State of New Mexico
 Energy, Minerals and Natural Resources

WELL API NO. 30-045-25419
5. Indicate Type of Lease STATE <input checked="" type="checkbox"/> FEE <input type="checkbox"/>
6. State Oil & Gas Lease No. B-10405-89
7. Lease Name or Unit Agreement Name STATE N
8. Well Number 1M
9. OGRID Number 372171
10. Pool name or Wildcat BLANCO MV/BASIN DK

STATE N 1M

BRADENHEAD REPAIR

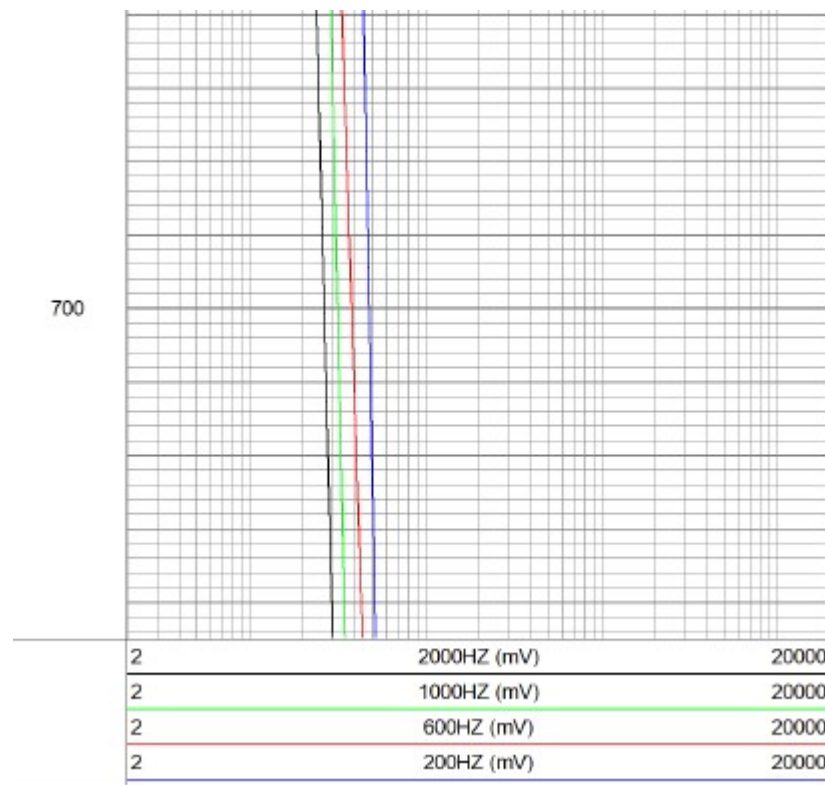
I'm not sure I agree with your assessment on the audio logs and no movement, there is variation between the two and there is peaks and valleys between them. As an example, below I provide a screenshot of an audio log with no movement which is in contrast to the one you show. Again, with the slow build up I don't think we are looking for a lot of movement. Also, between the logs I see considerably more potential channeling between them. The good bridge at 1110'-1130' is at the bottom of the Ojo which is known to be a water zone with higher natural permeability. I am out of the office after today until Tuesday. I would suggest continuing your review and we can discuss the path forward when I get back.

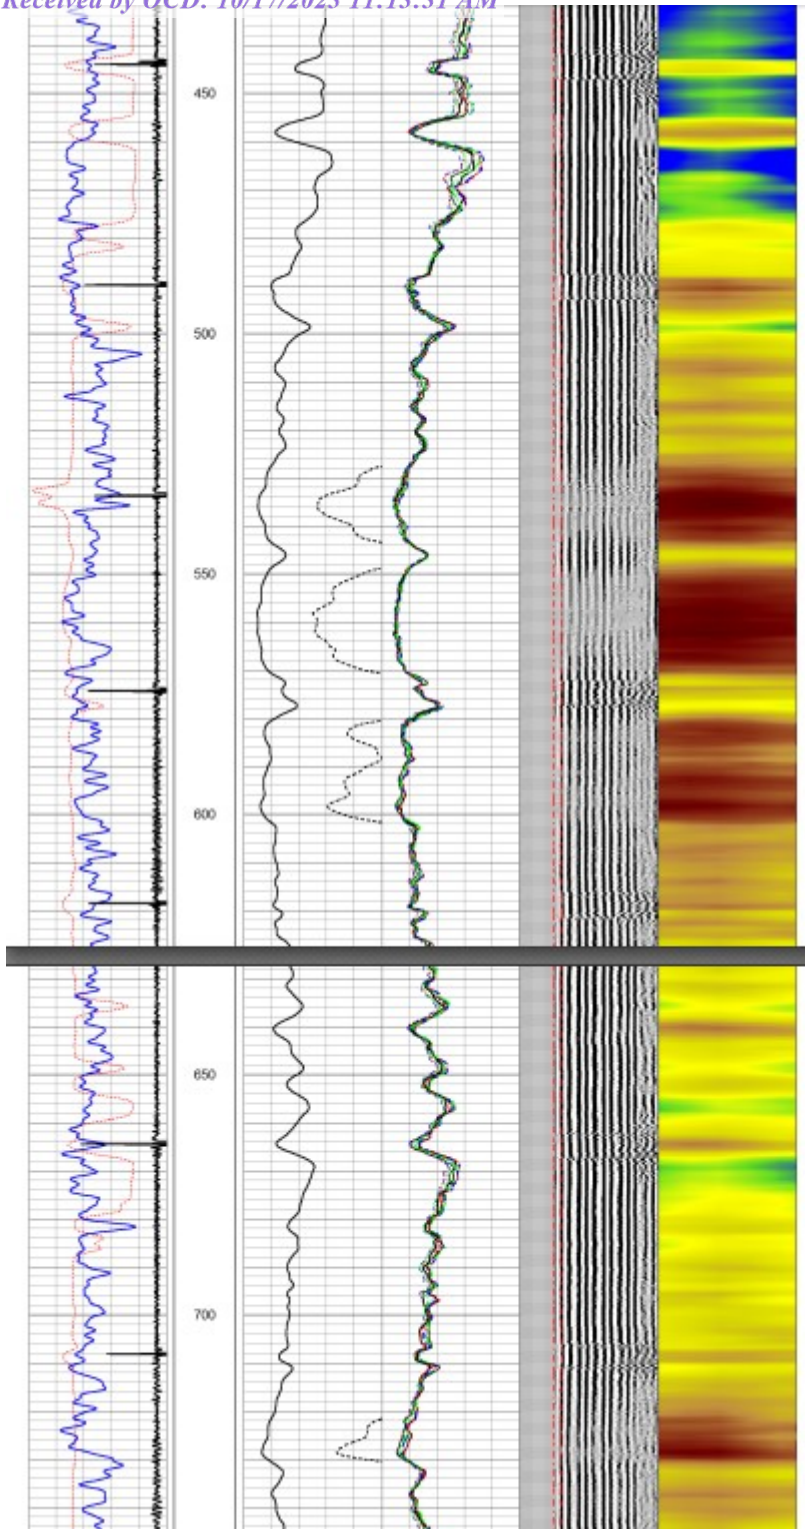
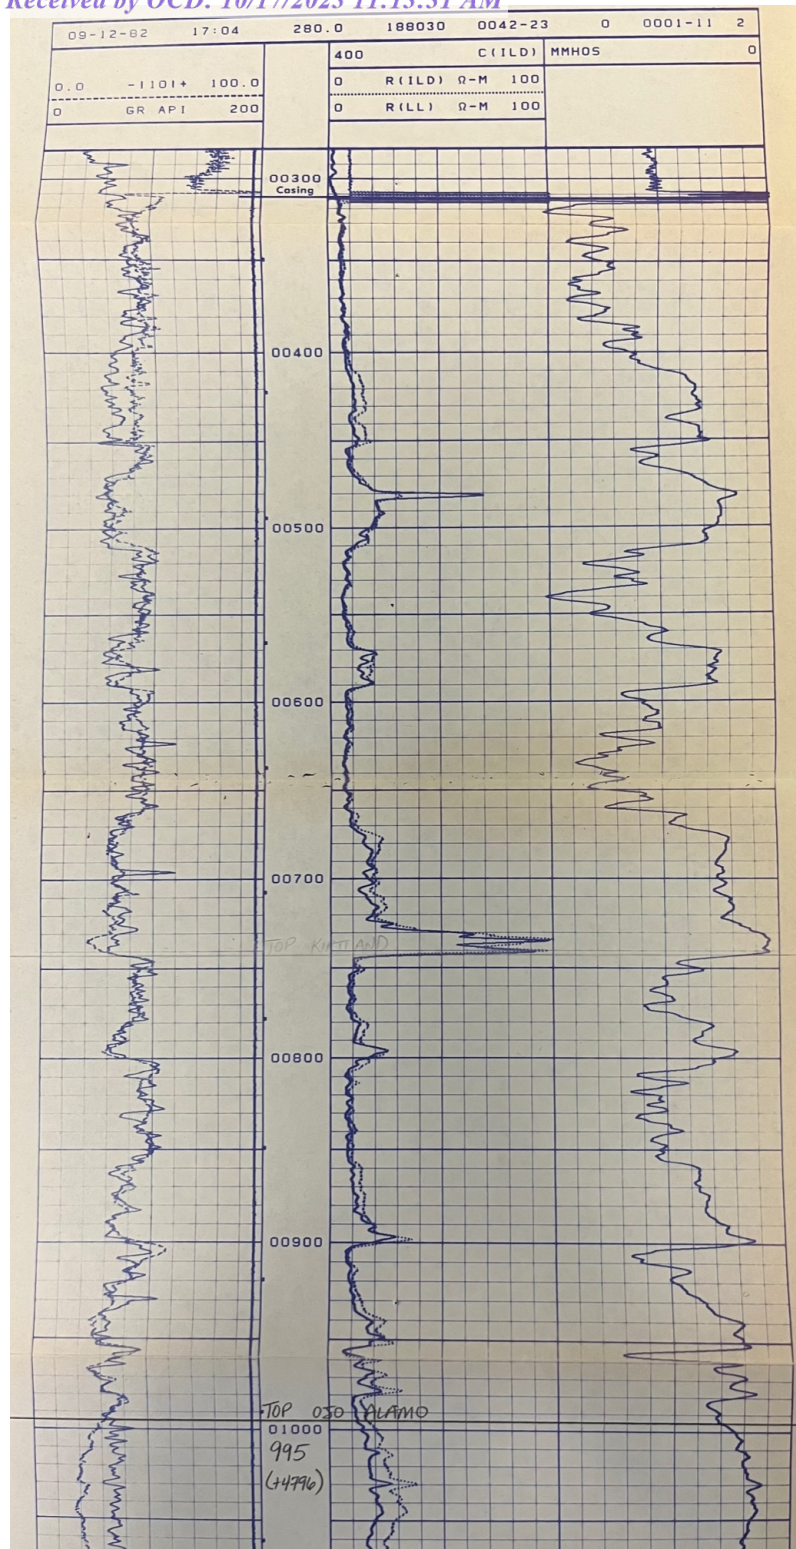
- Log response on the open and closed logging runs is quiet below 700'. No indication of fluid movement.
- There is noise on both the Braden head Open and Closed logging runs around 700'. (Increased amplitude across all wavelengths)
- The Braden head Open run indicates fluid movement from 350' – 450' above the TOC seen on the recent bond logs

- 670' was chosen for the lack of cement quality on the RBL seen below
- DIL shows a zone with resistivity 720'-745' (this interval could be the source of the braden head gas)

We would recommend remedial action by

- Perforating at 670'
- Squeeze cement into the perforated interval
- Drill out cement
- Perform MIT
- Return the well to production while monitoring an open Braden head to the pit tank

Schematic - Current

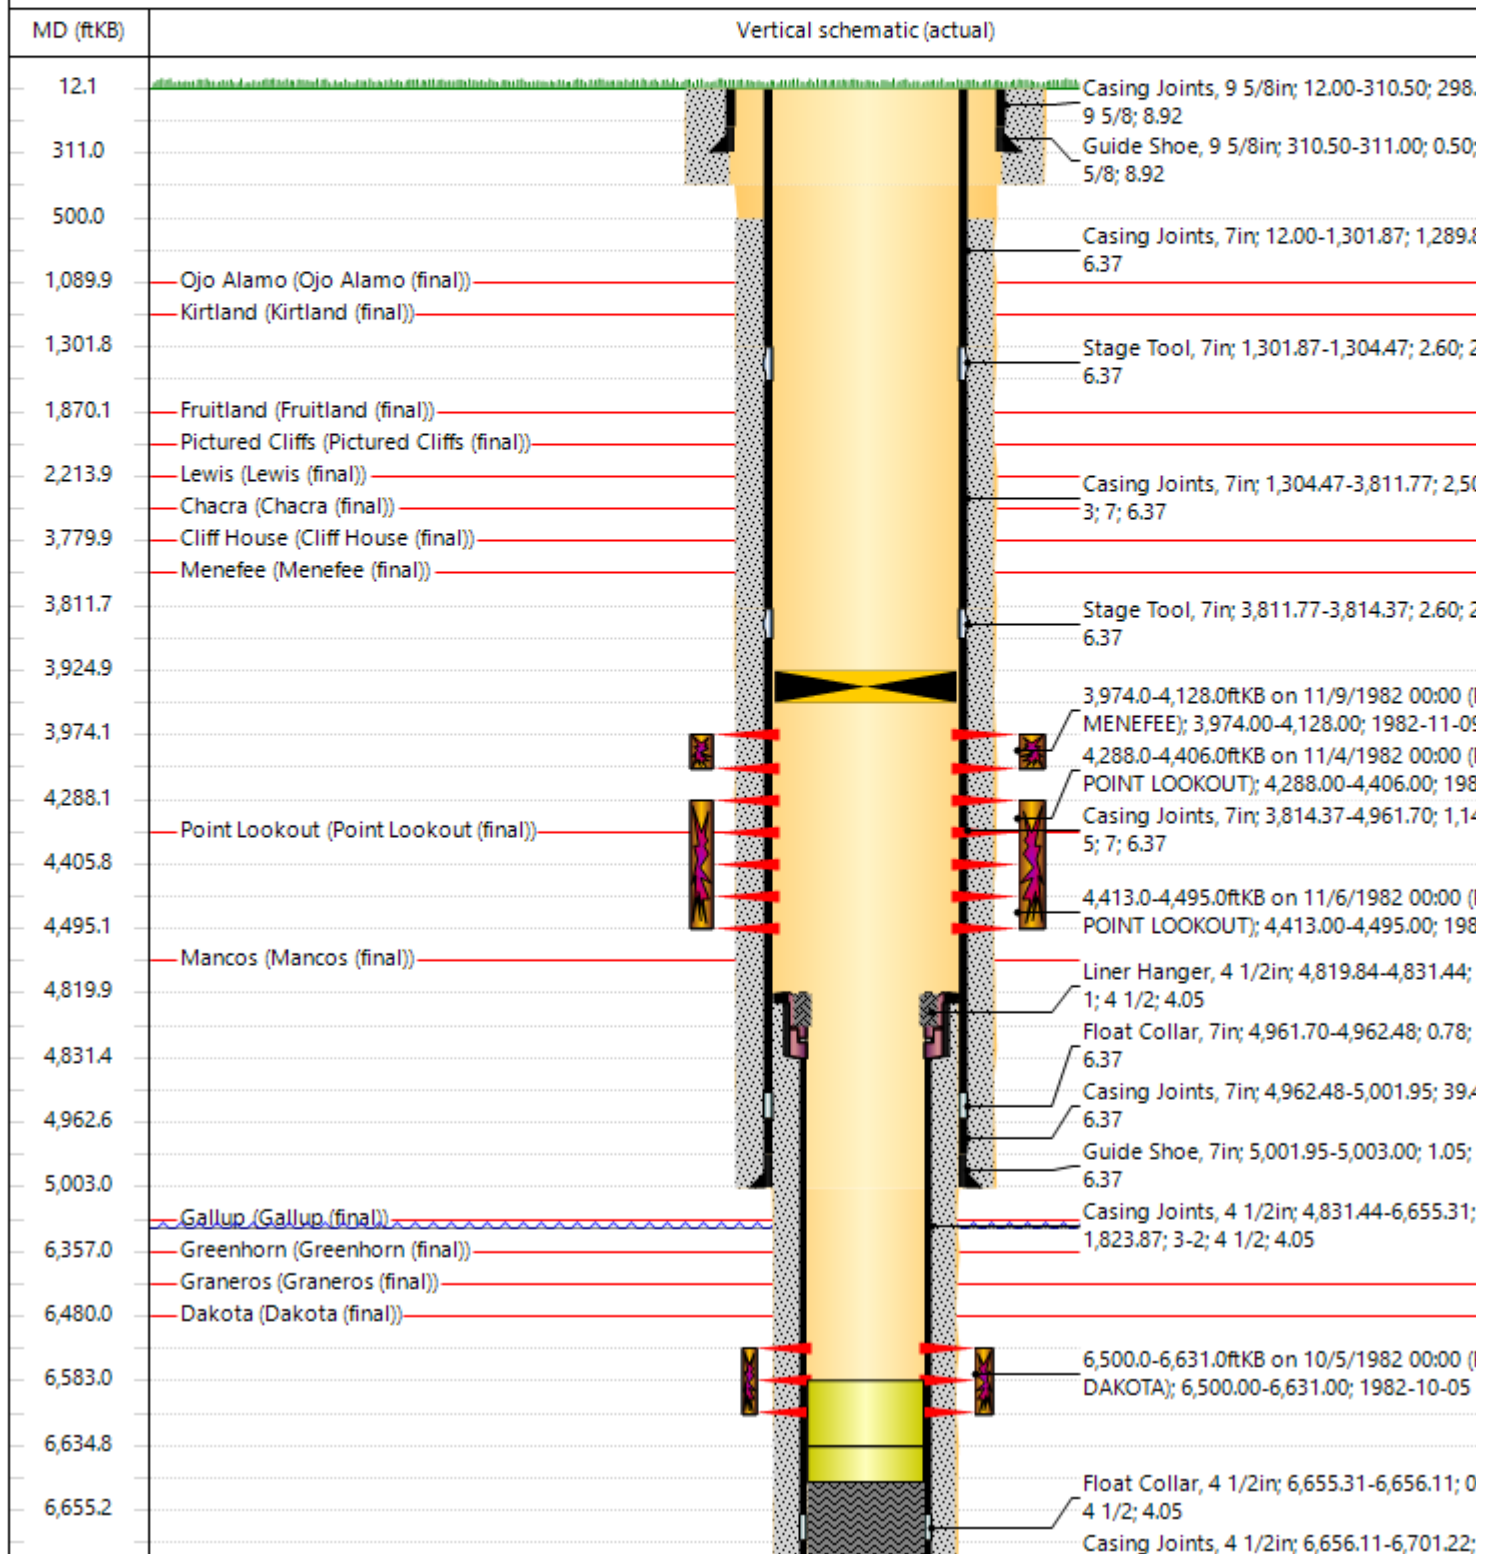
CBL: adequate >80% cement bond to formation and production casing from DV tool at 1290' – 450'

RBL: shows more than adequate bond >80% isolating all formations below ~500'. Also indicates no channeling.

Temperature Survey: shows a deviation at ~422'. Wellbore has a gradient of 2deg/100', above 422' gradient is ~1deg/100'. This is indicative of gas flow.

Surface Casing: Shoe at 311'. Cemented to surface.

Initial Production Casing Cement Report: Circulated 10 BBL cement to surface. Circulated excess cement to surface, and cement intrusion into a depleted zone dropped adequate TOC to ~450'

- Due to the results of the primary cement job, we think there is low probability of isolating the exposed formation 311'-450' through remedial cementing.

Reservoir engineering analysis of Resistivity and SP Logs: indicates there is no freshwater zones in the depths of 311'-450'. Also indicates there could be a gas bearing permeable sand between 311'-450'.

All of the above information leads us to think that the BH gas and associated pressure is coming from a gas bearing stringer somewhere between 311'-450'.

- Tie in BH to produce gas to pit, thus preventing gas intrusion/contamination into any possible fresh water zones within that exposed 311'-450' interval.
 - This would eliminate BH pressure/gas on exposed formation from 311'-450', better protecting any exposed freshwater zones.
